IREDELL COUNTY HEALTH DEPARTMENT

IMPROVEMENT PERMIT / AUTHORIZATION TO CONSTRUCT / OPERATION PERMIT / EXISTING SYSTEM

SITE ADDRESS: 135 UNION CHAPEL DR. MOORESVILLE PHONE: 260-579-5707 ALT. PHONE:

PAGE 1: APPLICATION FORM

INITIAL SITE SKETCH

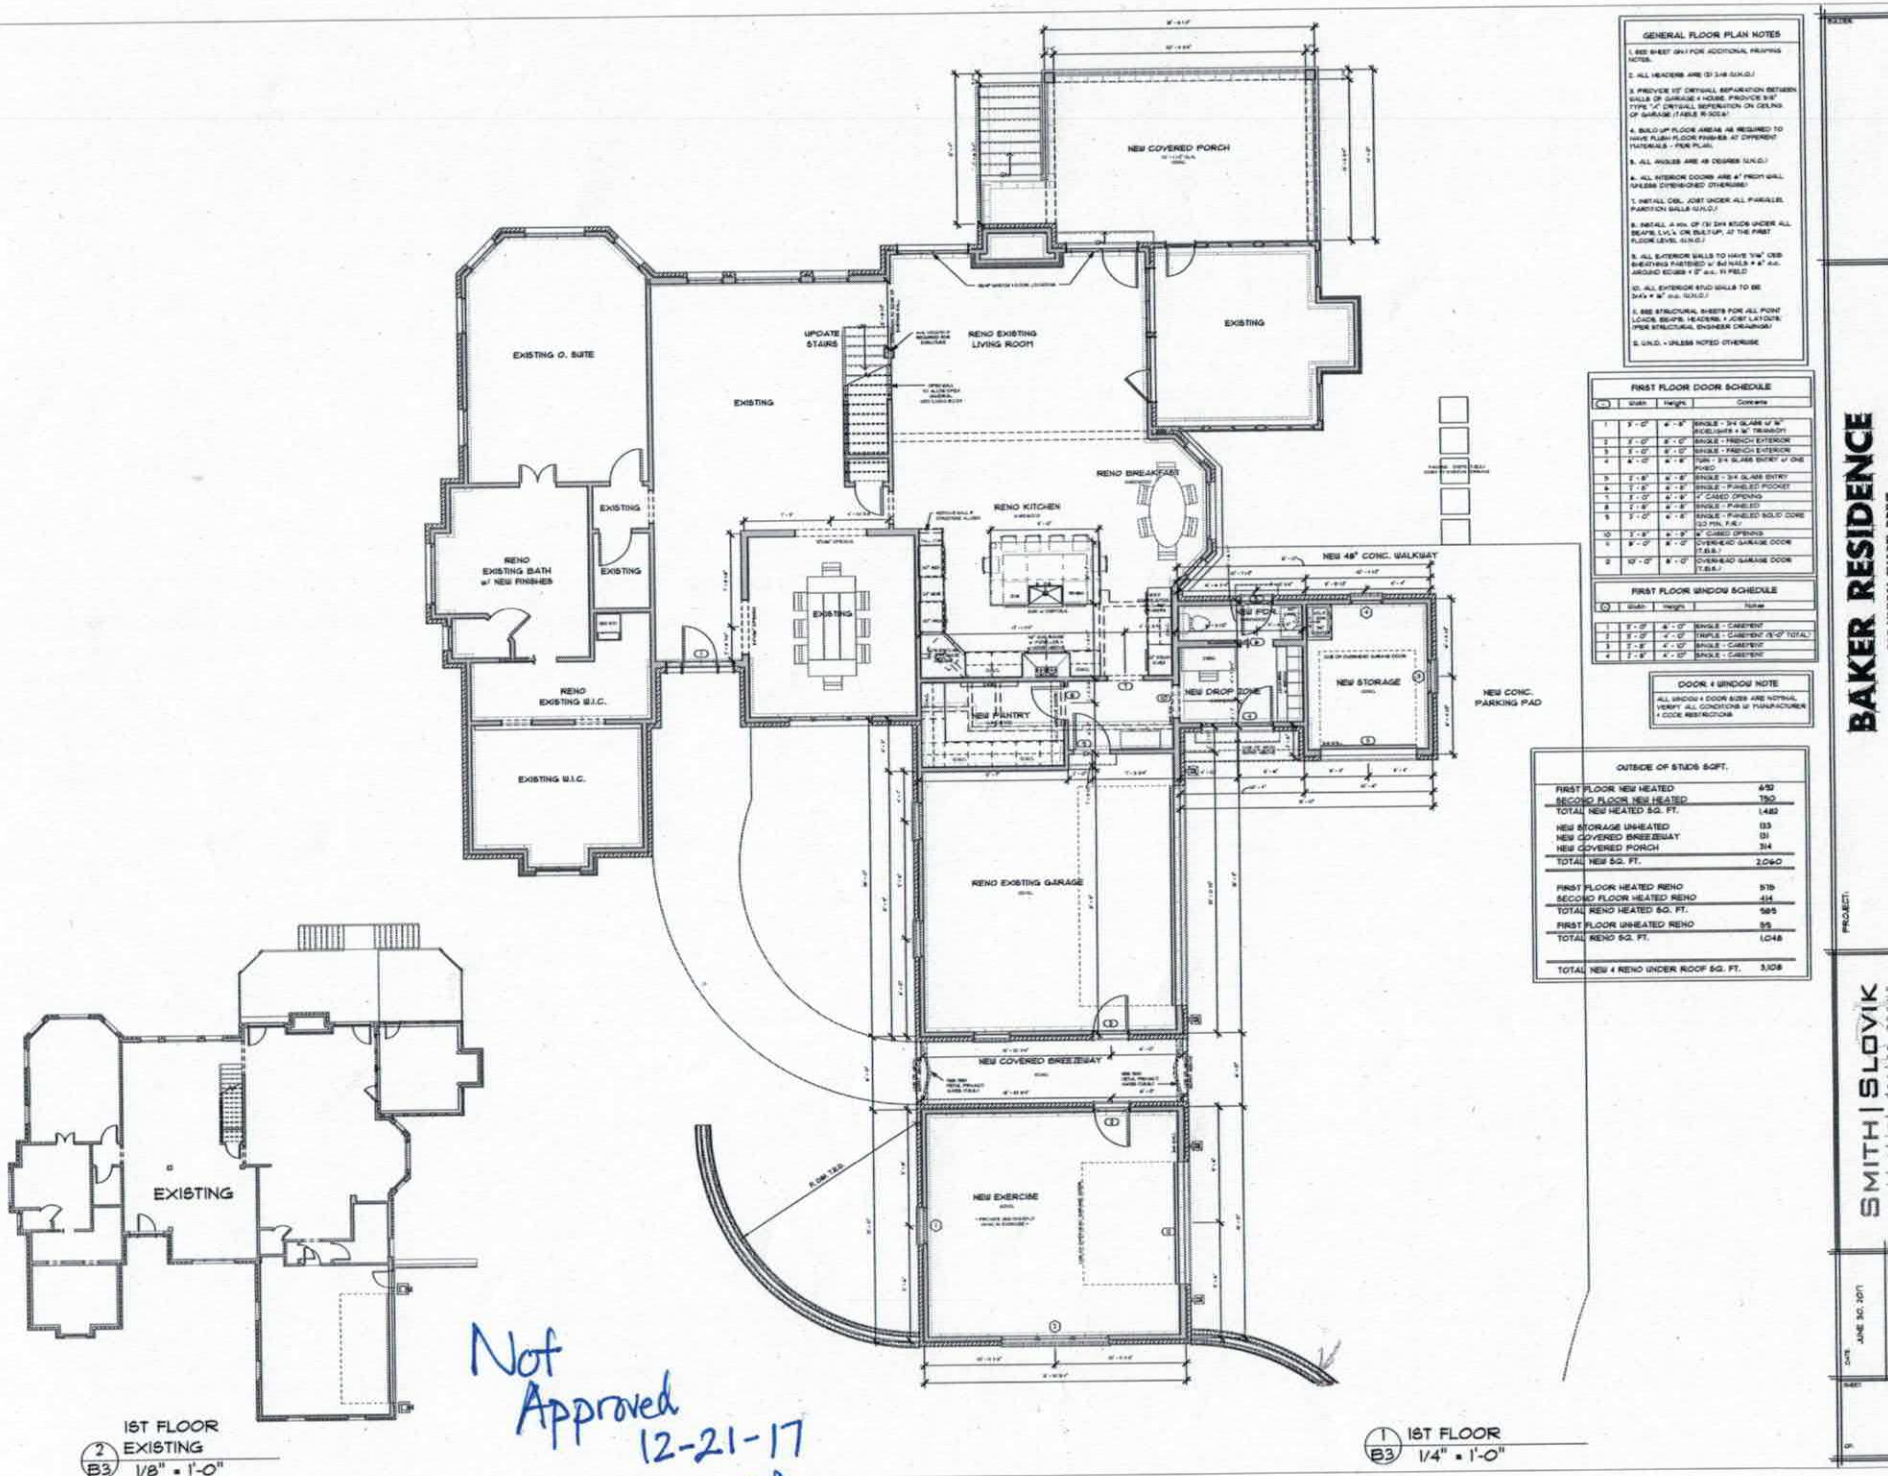
Comments / Conditions: ADDING GARAGE, POOL HOUSE & POOL
KEEP WATERS EDGE OF POOL 15' FROM TANKS
IF GARAGE CUT IS ≥ 2' STAY 15' FROM SEPTIC FIELD
IF IT IS < 2' STAY 5' FROM DRAIN FIELD

NO FOUNDATION DRAIN ALLOWED AROUND GARAGE

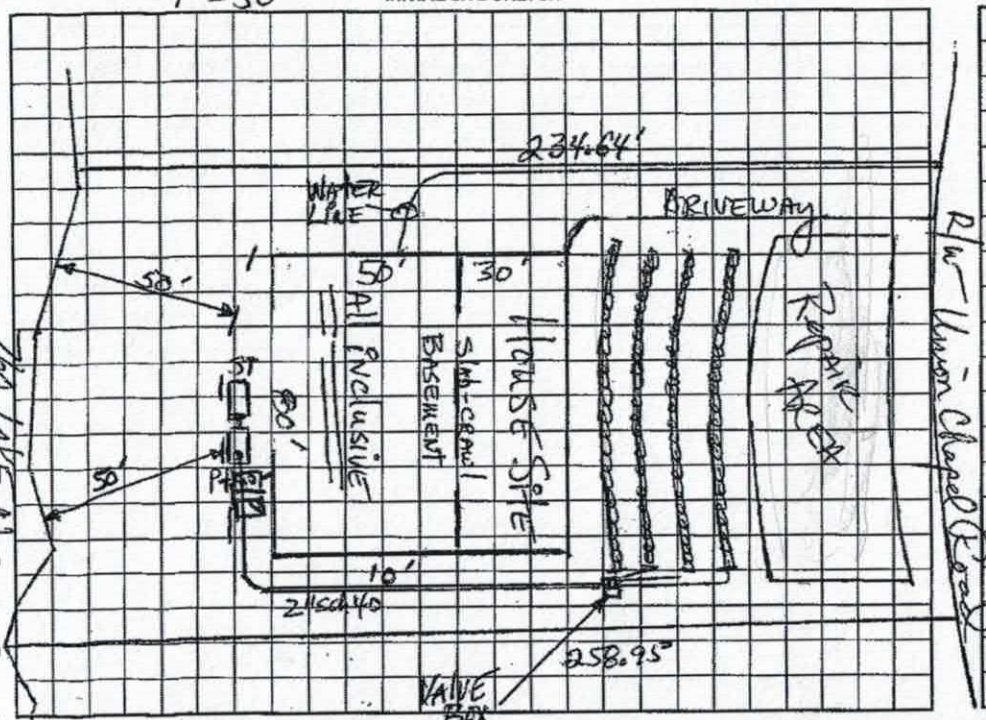
Not Approved 12-21-17 BA

Corban Homes will not do an end cut greater than two feet. Thanks.

Ben, this email is to provide documentation that Corban Homes of Cabarrus County Inc. will not install French drain around retaining wall and garage addition at address referenced above. Please let me know if you need any other information. Thank you.

INITIAL SITE SKETCH

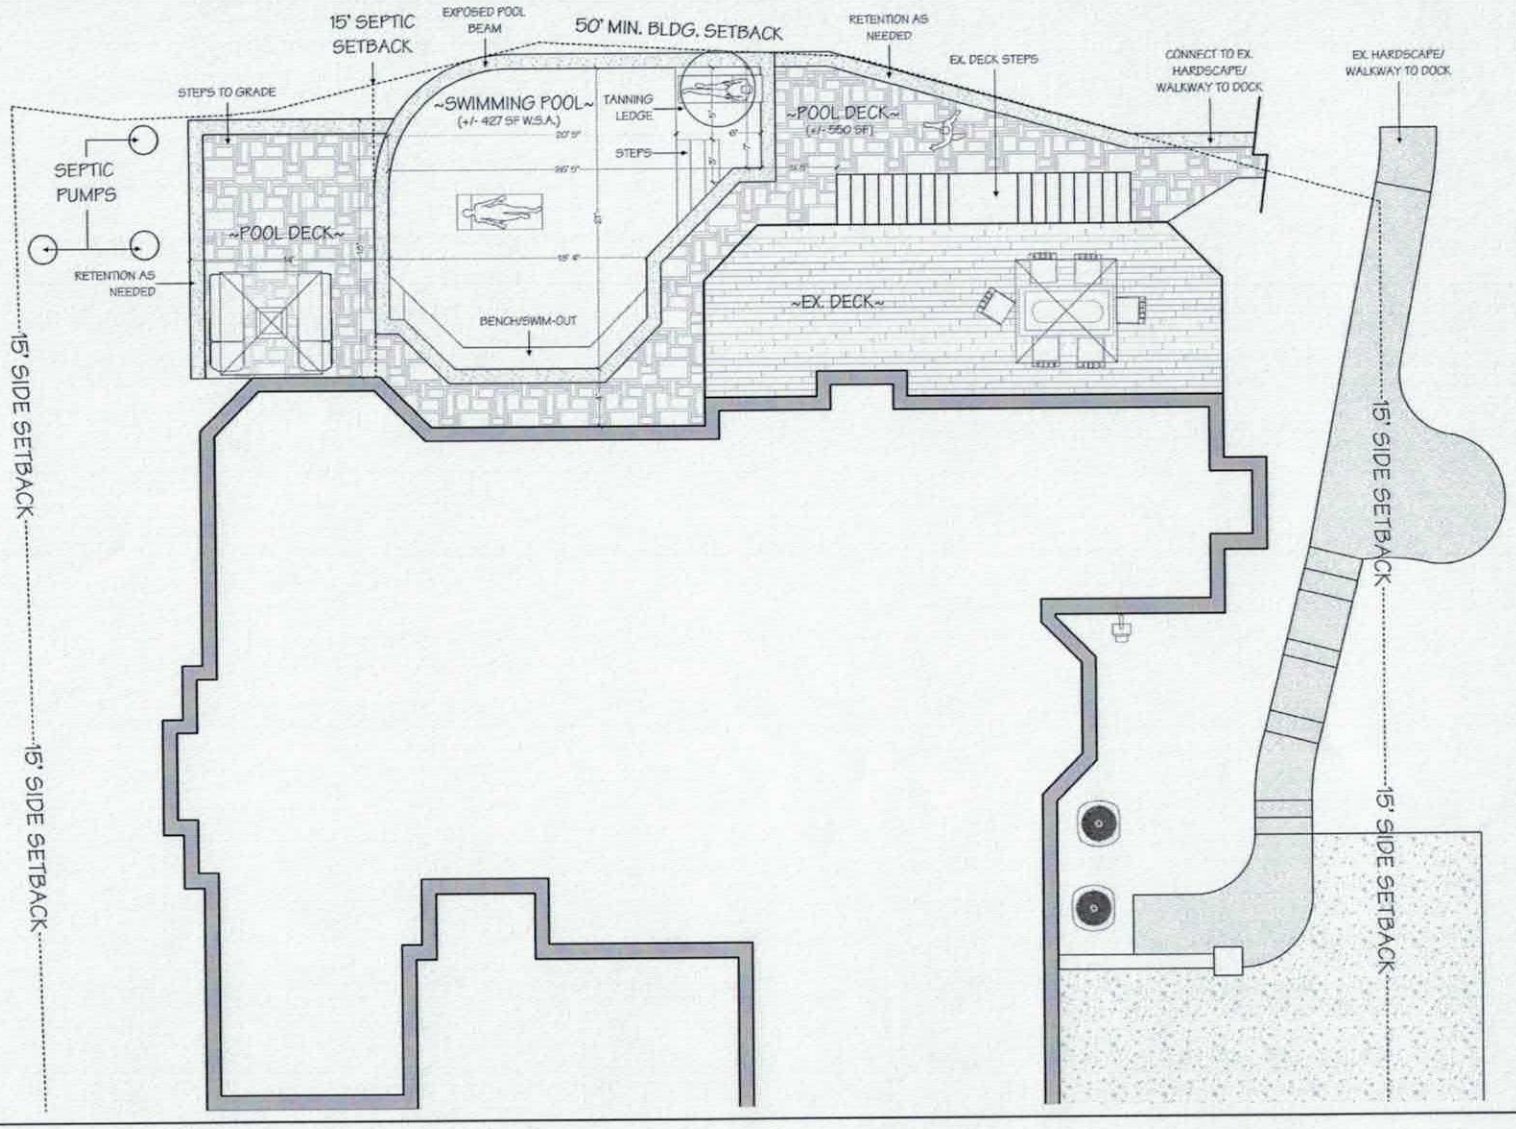
1-23-01 Revised house & site plan; appears in compliance w/ I.P.

Drainfield, Tanks, Supply lines inspected 7/18/01
